Access Compliance Report

Public Rights-of-Way

(Curb Ramps)

Intersection ID: 11482	Main Street: PARKWOOD_AV	Cross Street: SEIGLE_AV	Location: NE
ADA ID: D406CC7AE13C	Ramp Type: Perp	Initial Pass/Fail: Fail	Overall Compliance: No
Severity Score: 8.75			
Codes/Mitigation Info/Possible Solution		Field Measurements/Component Compliance

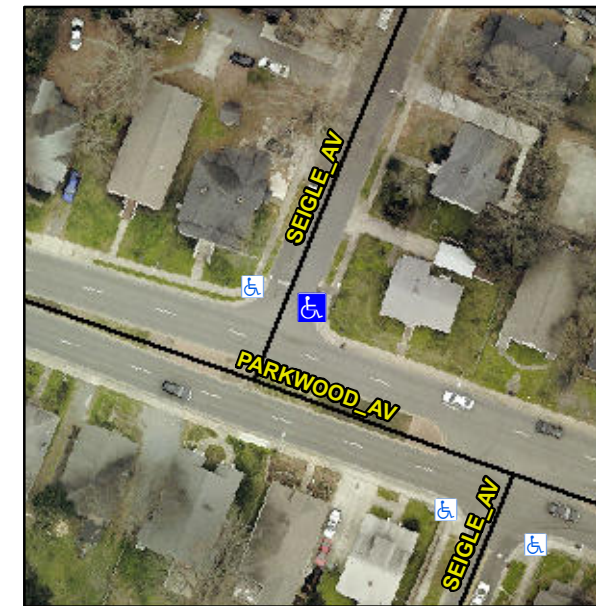
Not Found, R304.5.1

Compliance	Description	Data	Compliance	Description	Data
N/A	Ramp Length (in)	65.0	Yes	Ramp Slope (%)	5.7
No	Ramp Width (in)	47.0	Yes	Ramp XSlope (%)	0.2
N/A	Flare Type LT	N/A	N/A	Flare Type RT	N/A
N/A	Flare Slope LT (%)	N/A	N/A	Flare Slope RT (%)	N/A
N/A	Flare Traversable LT?	N/A	N/A	Flare Traversable RT?	N/A
N/A	Landing Length (in)	N/A	N/A	DWS Provided?	N/A
N/A	Landing Width (in)	N/A	N/A	DWS Contrast?	N/A
N/A	Landing Slope (%)	N/A	N/A	DWS Length (in)	N/A
N/A	Landing X Slope (%)	N/A	N/A	DWS Full Width?	N/A
N/A	Landing Curb? (Y/N)	N/A	N/A	DWS Offset (in)	N/A
N/A	Shared Landing?	N/A			
N/A	Gutter Ponding?	N/A	N/A	Gutter Slope (%)	N/A
N/A	Gutter Lip Ht (in)	N/A	N/A	Gutter X Slope (%)	N/A
N/A	Painted X Walk1?	No	N/A	Painted X Walk2?	N/A
	X Walk 1 Direction	To NW		X Walk 2 Direction	N/A
N/A	X Walk 1 Width (in)	N/A	N/A	X Walk 2 Width (in)	N/A
	X Walk 1 Slope (%)	5.5		X Walk 2 Slope (%)	N/A
	X Walk 1 X Slope (%)	3.4		X Walk 2 X Slope (%)	N/A

Remove & Replace Entire Ramp.
